Remarks

Amendments to the Drawings:

The attached sheets of drawings include changes to Figs. 7 and 12. These sheets, which include Figs. 7, 12A and 12B, replace the original sheets 7 and 12 of the original drawings. In Fig. 7, previously omitted element 171 has been added. In Fig. 12, the sheet has been changed to separate Fig. 12 into Fig. 12A and Fig. 12B.

FIG. 12A

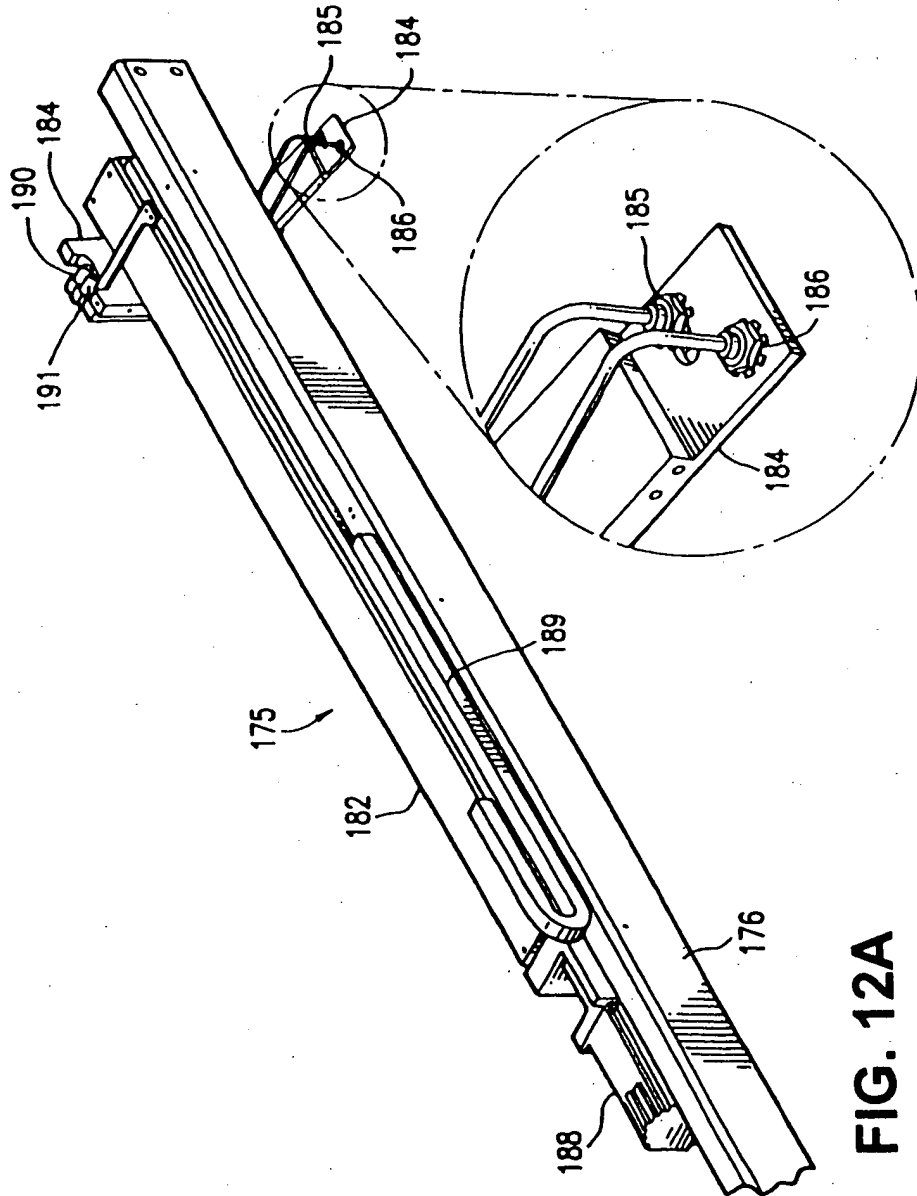
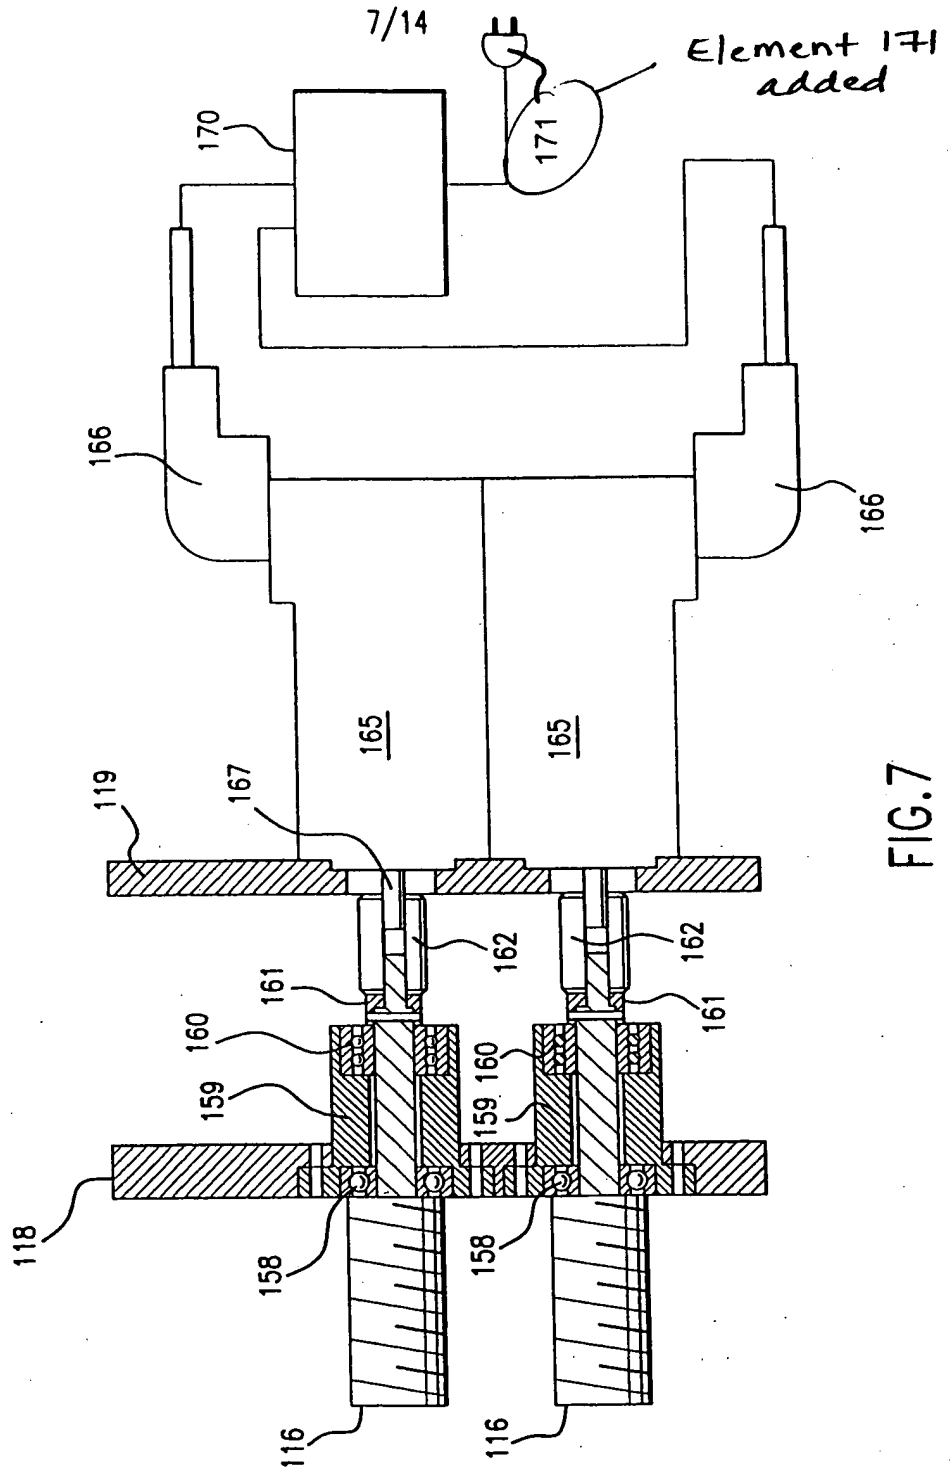
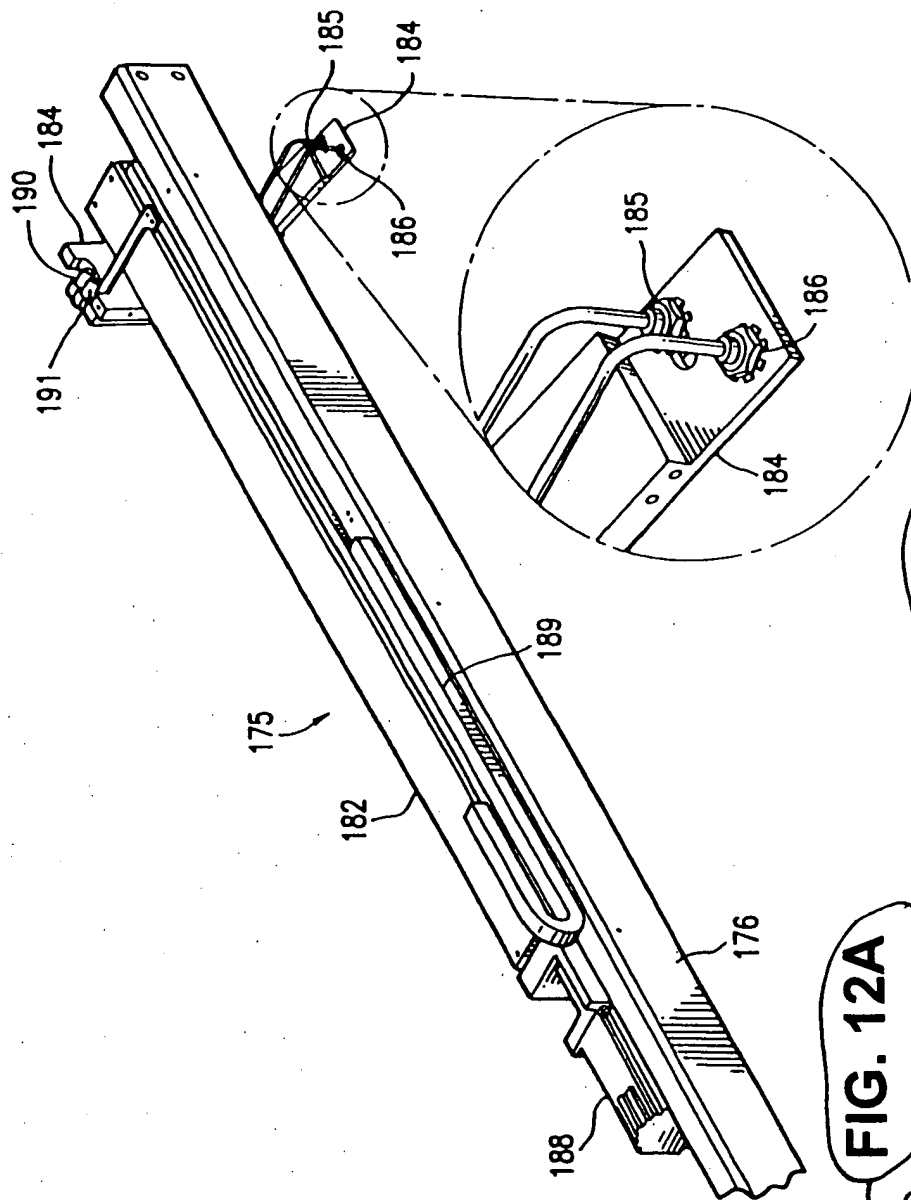
caption
added

caption
added
